MEMORANDUM

DATE	July 18, 2024	PROJECT NO.	23225
TO	Jeffrey Tsumura, Senior Planner	PROJECT	194-198 Castro Street, Mountain View
OF	City of Mountain View, Community Development Department	FROM	Hannah Simonson, Project Manager, Cultural Resource Planner
CC	Christina Dikas, Principal, Page & Turnbull	VIA	Email

REGARDING 194-198 Castro Street, Mountain View Project Evaluation: HRA Peer Review & SOI Standards Compliance Analysis Memorandum

A HISTORIC JURIAN BUILDING STREET LEVEL VIEW FROM CASTRO STREET (NEW ADDITION BEYOND)

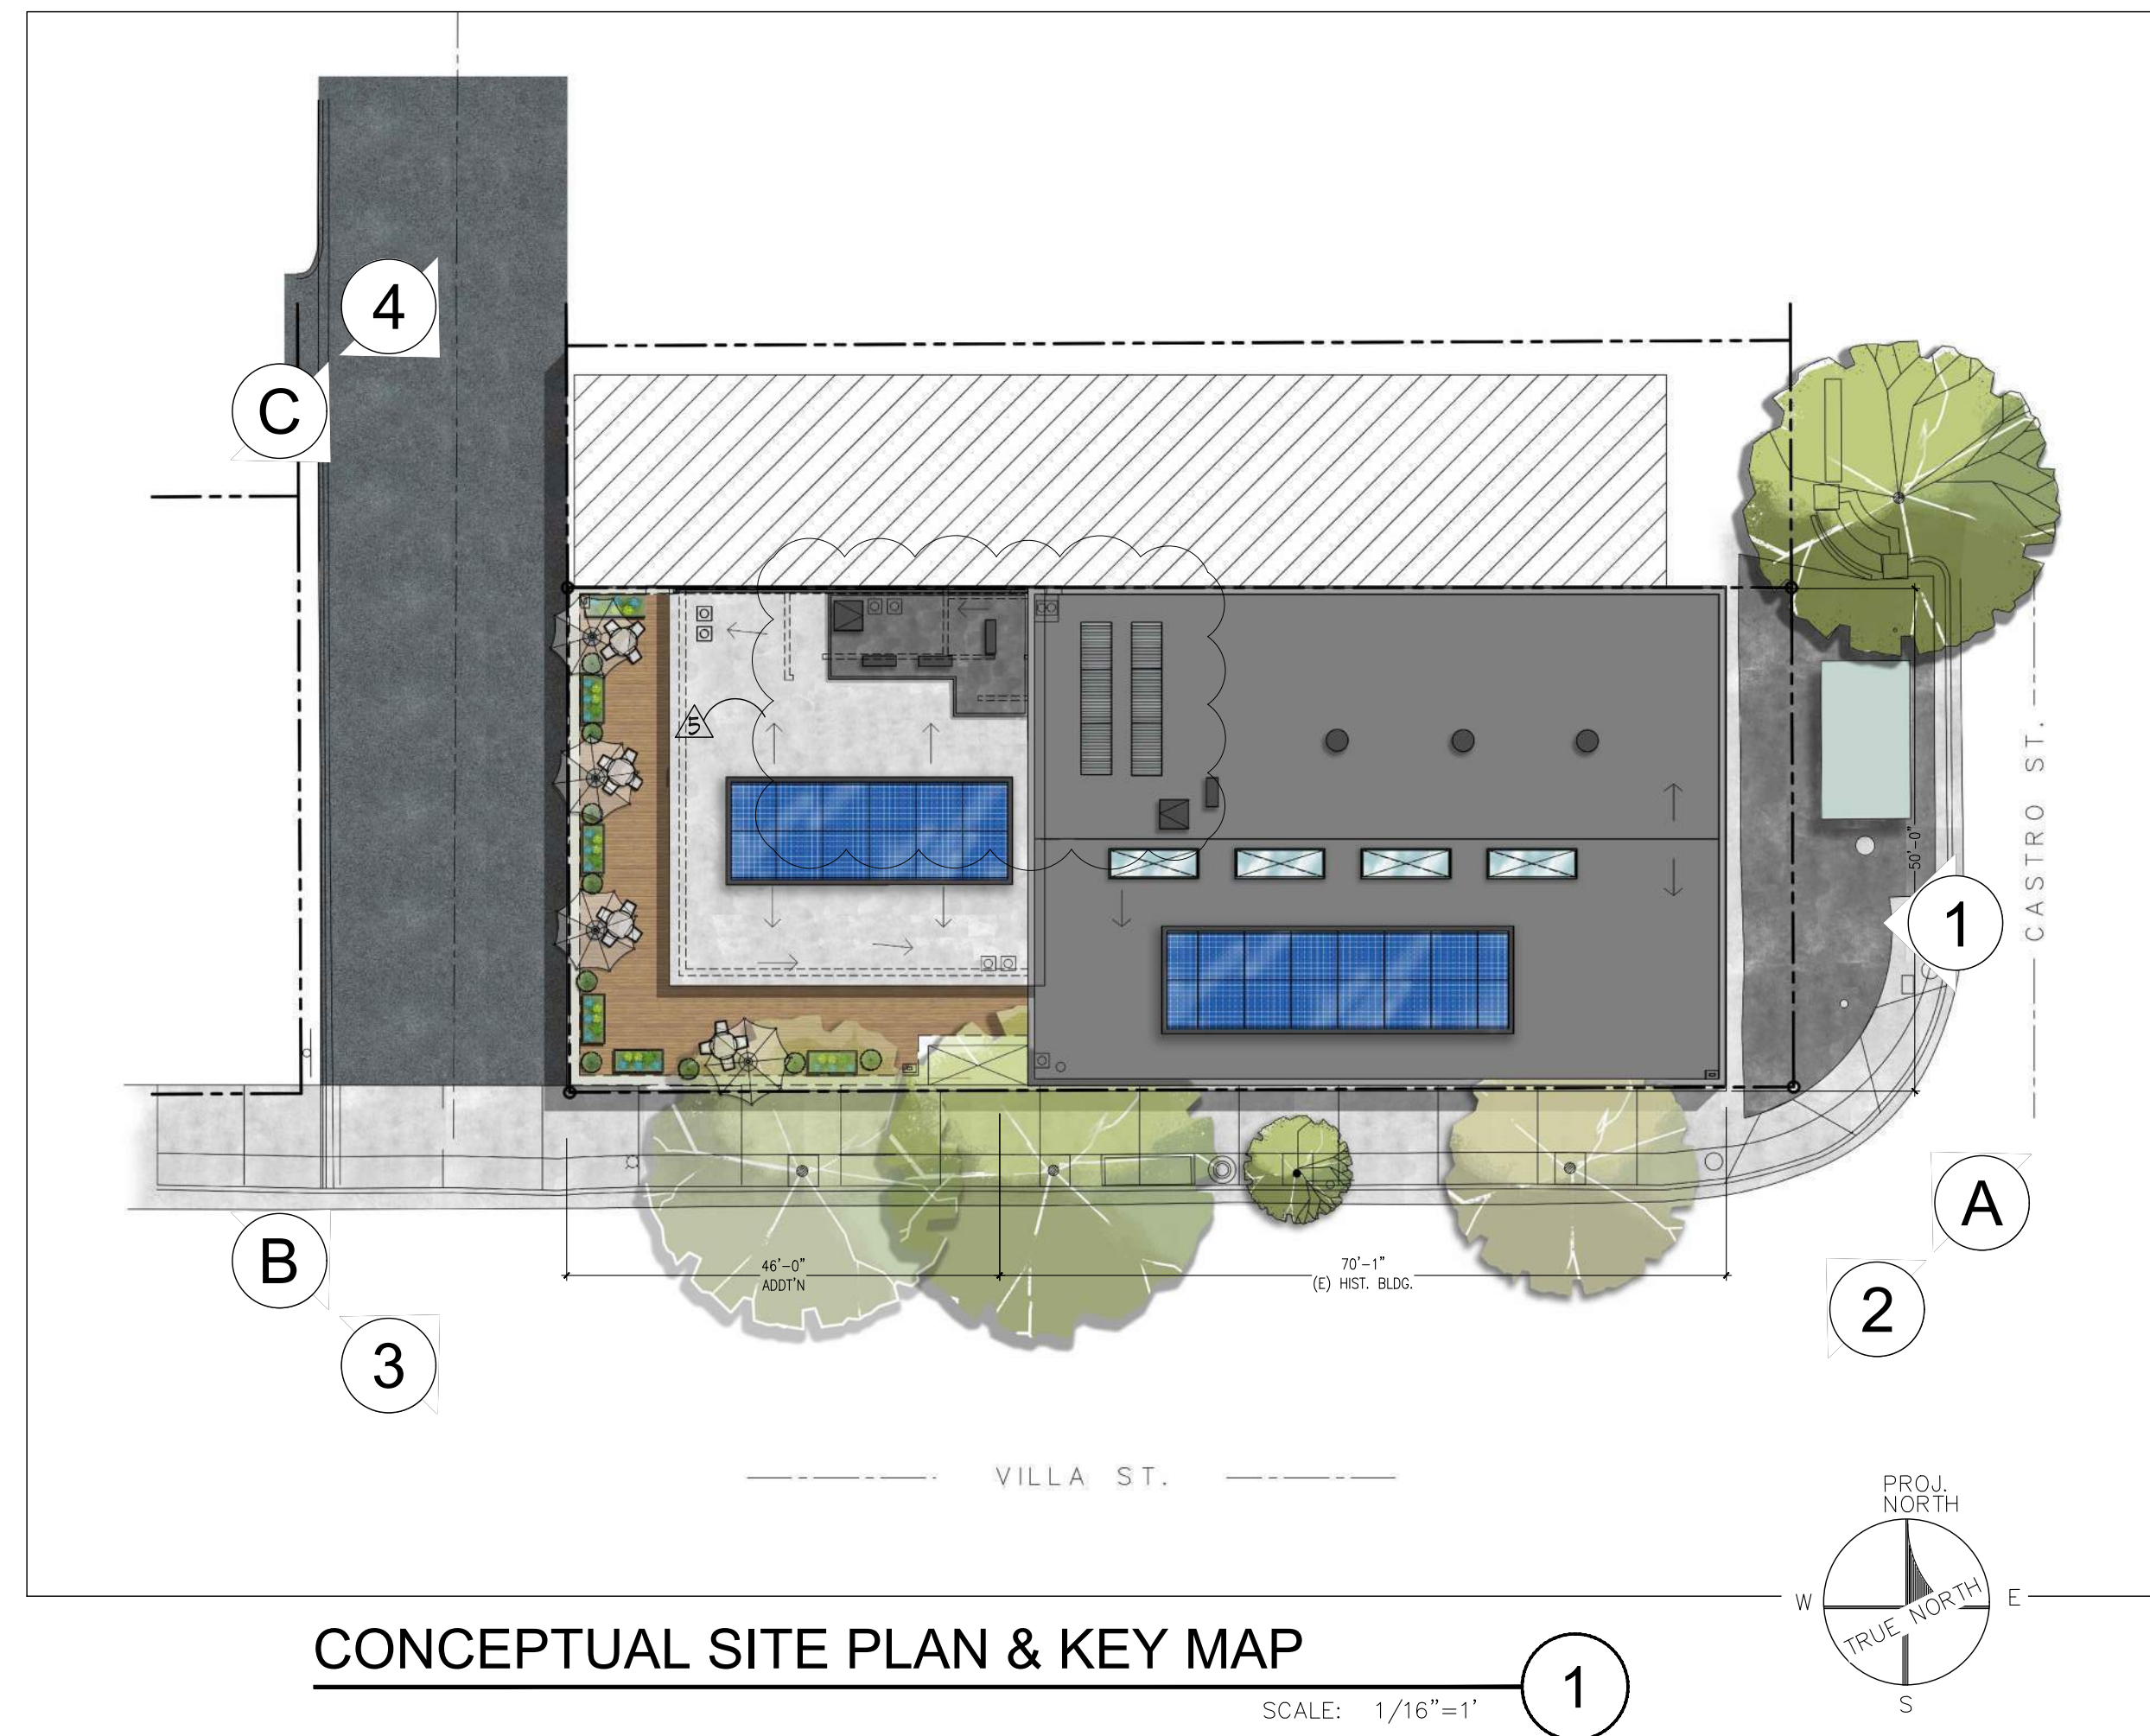
The proposed project at 194 Castro Street includes a rear three-story addition and interior tenant improvements (**Figure 3 - Figure 6**). The addition will be connected at the interior, necessitating demolition of large portions of the rear wall of the historic building; however, the parapet at the rear façade will be retained and the new addition will read as a separate building from the outside. The proposed addition will have an inset alcove where it connects to the rear façade of the historic building, along Villa Street, which will provide a visual distinction from the historic building and allow the historic building to retain its massing and corner parapet features.

- The ground floor storefront windows and transoms at the proposed addition are also proportional to the openings at the historic building.
 - The addition will have an inset alcove immediately to the west of the existing historic building to provide a visual and physically delineate the addition from the historic building.

will provide a visual break between the historic building and the addition, and will allow the southwest corner of the historic building, including the parapet merlon, to remain intact. As such, the proposed addition largely reads as a separate new downtown commercial building that could be abutting the historic building.
